To: Kristopher Byrd, Well Construction and Compliance Section Manager
From: Travis Kelly, Well Construction Program Coordinator
Subject: Review of Water Right Application G-19008
Date: September 15, 2020

Application # G- 19008

TO: Water Rights Section Date 02/12/2024
 FROM: Groundwater Section Jen Woody
 Reviewer's Name
 SUBJECT: Application G- 19008 Supersedes review of 9/2/2020; 03/24/2023
 Date of Review(s)

Rivergreen Properties Well
at
Nestucca Bend

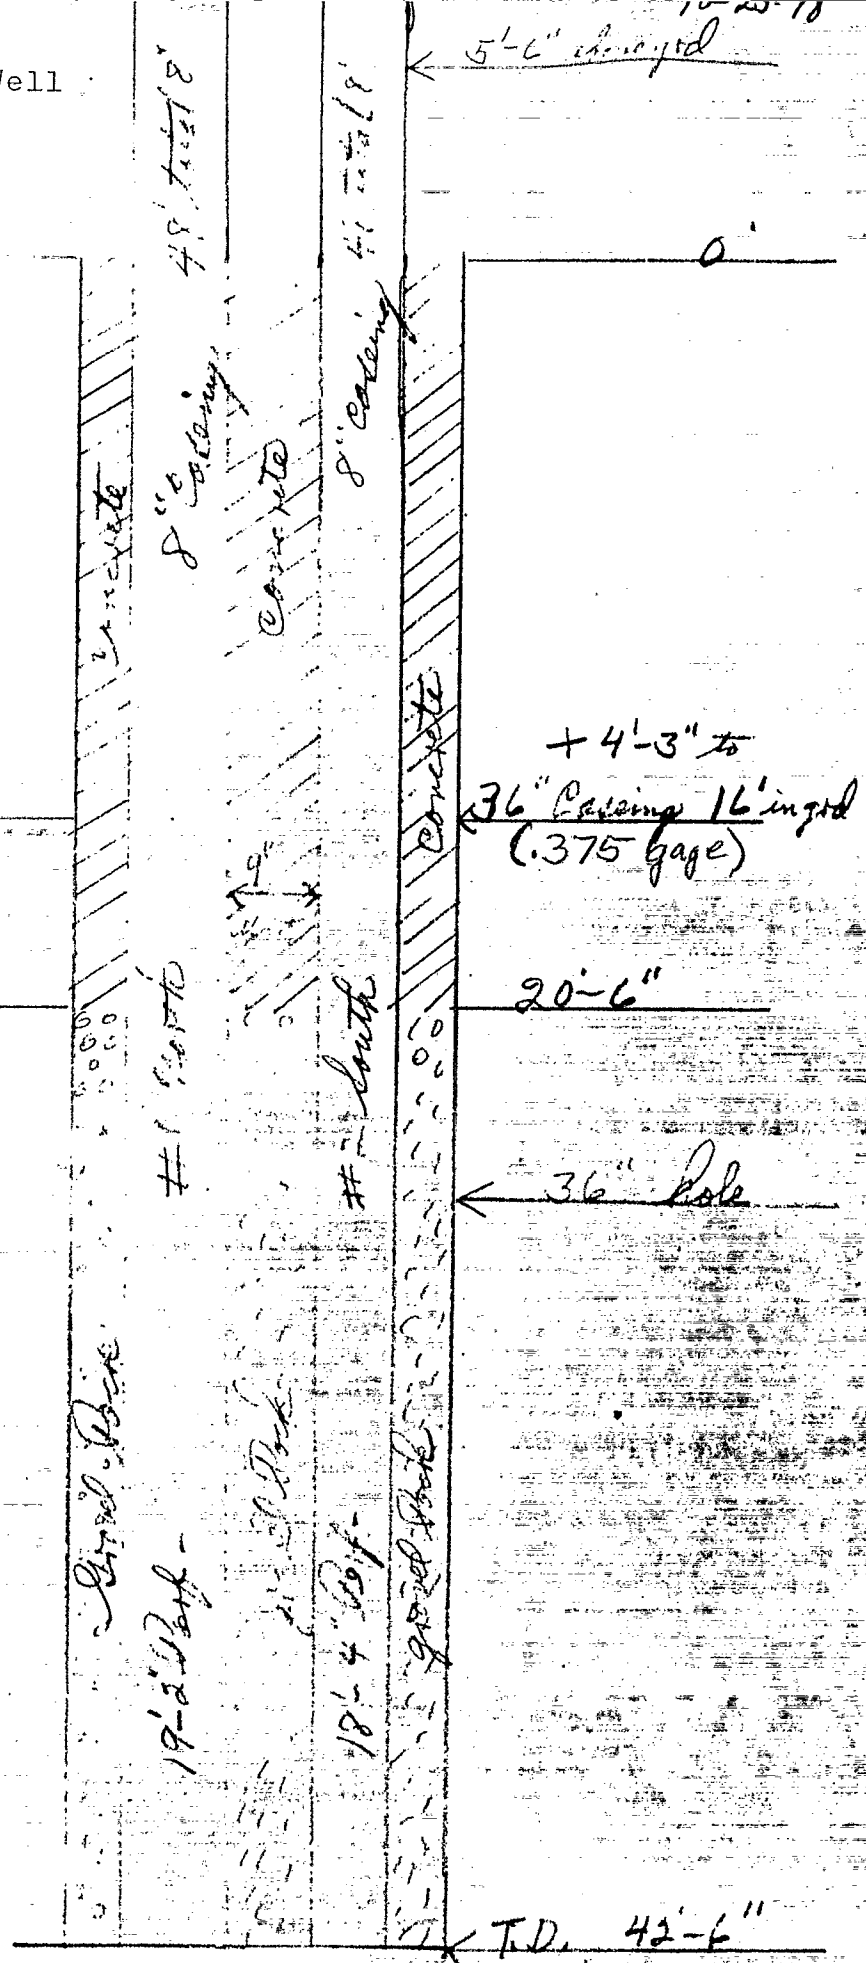
At present the well was drilled to 42' with 36" hole after which we set 2 - 8" casings from a +6' to 42' spaced 9" apart and filled with $\frac{1}{2}$ to $\frac{3}{4}$ " gravel. Ready mix was then poured around the 8" casings and inside the 36" casing.

We then proceeded to pull the 36" casing out, and it came out to 16' (bottom of casing below ground) and stopped. We could not get it to move again, and the cement is set.

We would like to have approval for use to cut the 36" casing off at ground level and bulldoze the dirt up around the casing to 22 or 23' above the bottom of seal as per our letters of October 12, 1978.

Milo Schnieder, well driller, came in to discuss the status of the gravel-pack well he is putting in at Nestucca Bend. He said that they were not able to completely extract the 36" casing after they installed the redimix seal. He said that after the gravel-pack was placed around the permanent casings (two 8" pipes), the redimix was introduced on top of the gravel-pack (20'-6" depth).

He said the 36" casing was raised 4'-6", but then it stuck. He said that by the time they got the jacks out to the site, the concrete had set up and they were not able to budge the 36" casing. He said that the two 8" permanent casings are 9" apart and are encased in concrete 36" in diameter from the surface down to a depth of 20'-6" below ground level.

I called Bil McCall at the Water Resources Department, and we both agreed that this constituted an effective annular seal.

I discussed this matter with Bill McCall of the Water Resources Board and we both agreed that the redimix concrete seal which completely fills the 36" casing and encases the two 8" well casings, constitutes an effective annular seal.

Accordingly, this construction is hereby approved.

I would recommend that you leave the 36" casing as it is at present (4.5' above existing ground) so that when the area around the well is filled and the well slab is poured, the top of the 36" casing will be above the slab. The two 8" well casings must be 18" above the slab.

Well # 3-a
Started 9-25-78

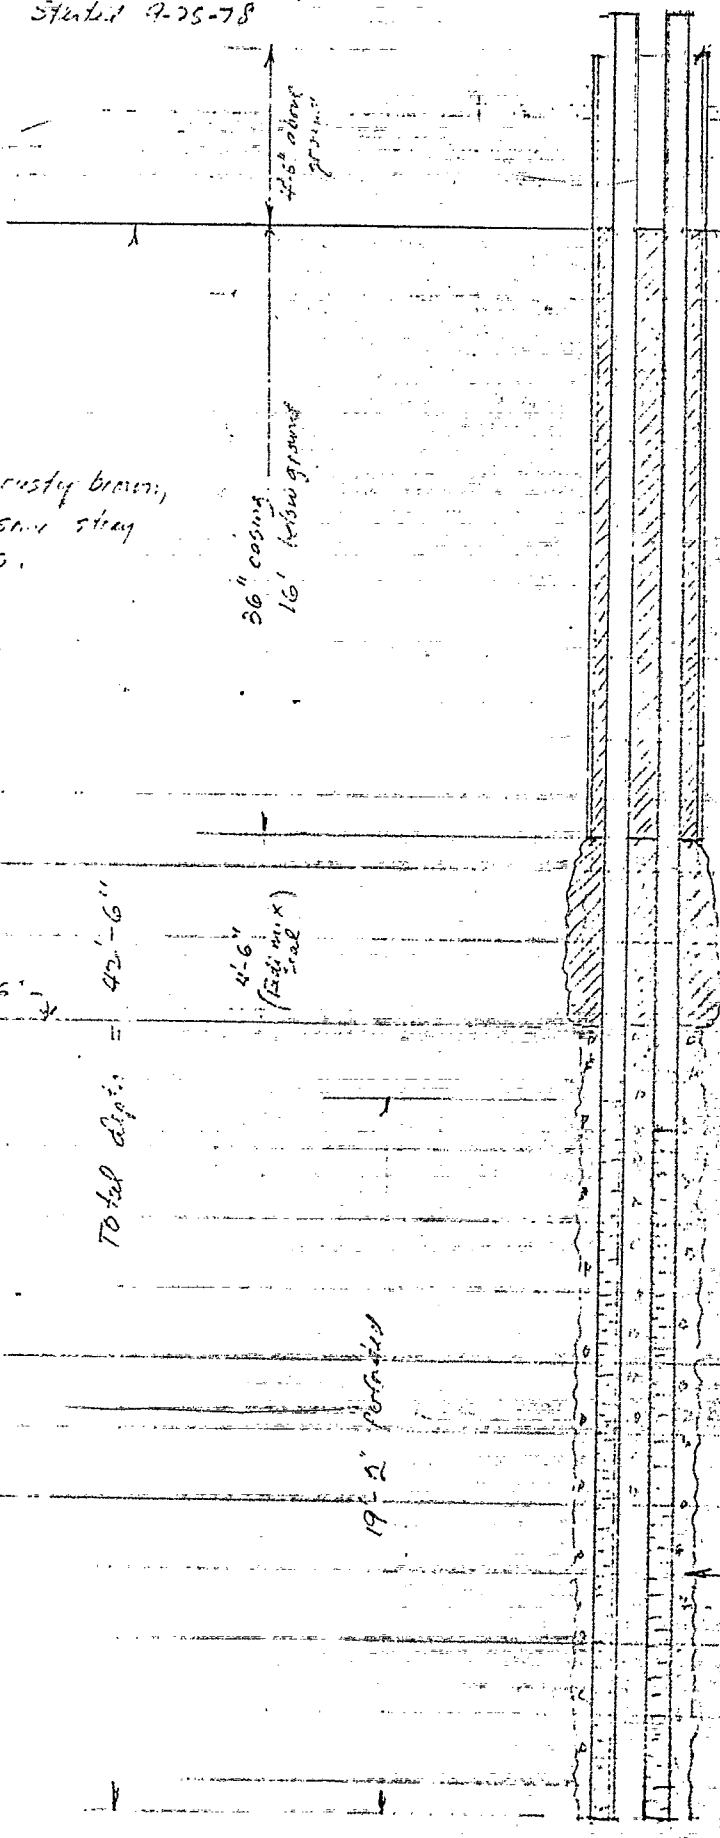
I drew a sketch of the well construction which is attached.

Figure 3. Stream Depletion

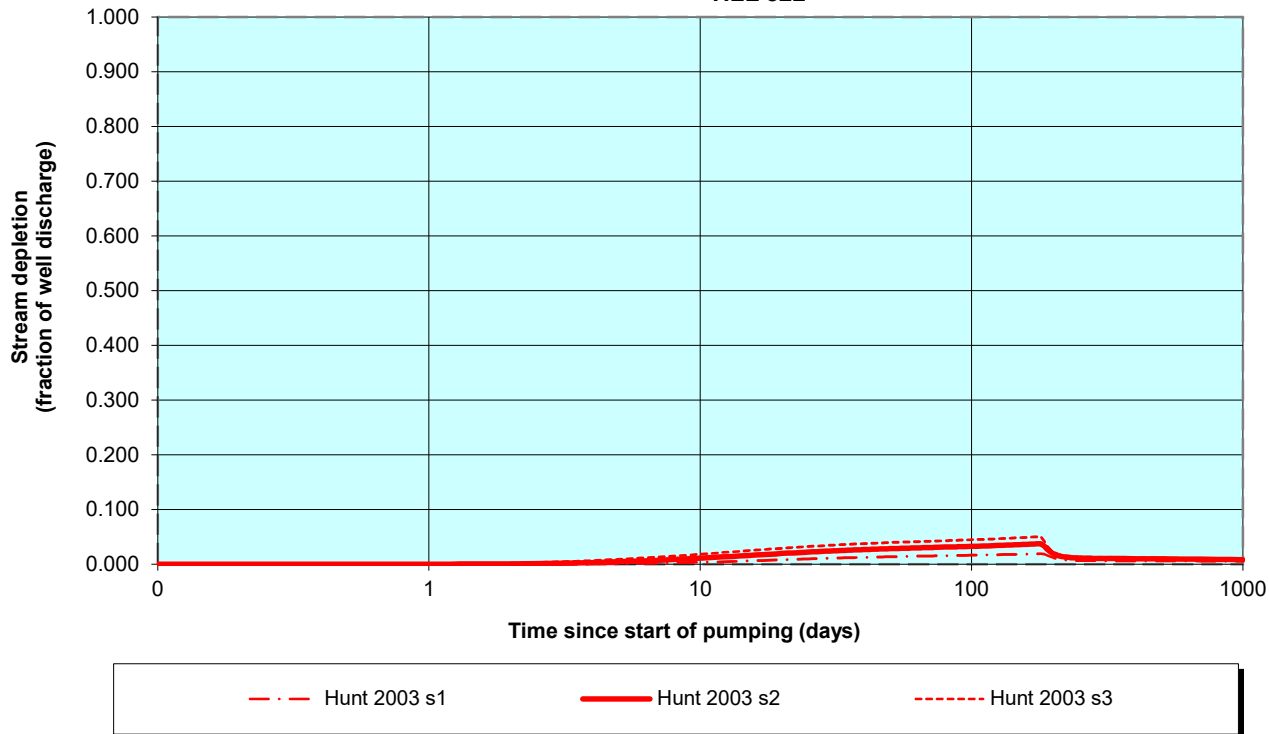
Comments: PSI is triggered because the well is in an unconfined aquifer and located less than ¼ mile from the Nestucca River.
